STAFF RECOMMENDATION

110 South 17th Street
March 17, 2021

Application: Partial Demolition

Description of Project: Application is to reconfigure the front porch on the historic house. The work is considered partial demolition.

DAVIS RESIDENCE

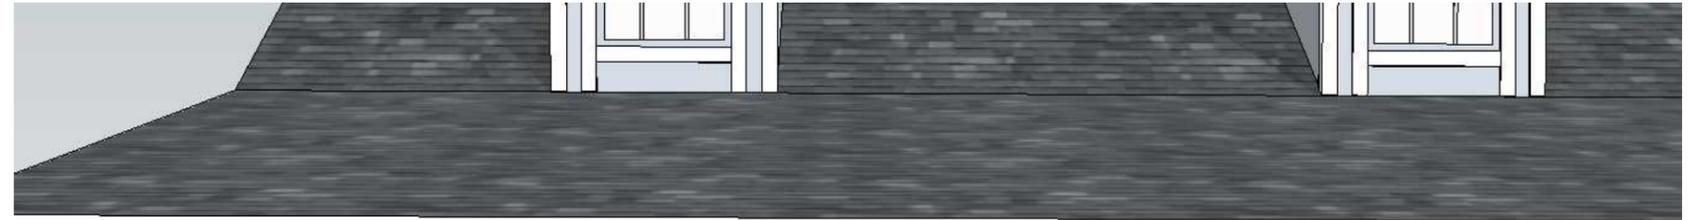
REPLACE STONE
FLOWERBED WITH
2'6" FENCE ●

ADD PAVED
WALKWAY ●

● REMOVE EXISTING
STONE/ BRICK WALL
TO ALLOW FOR WALKWAY
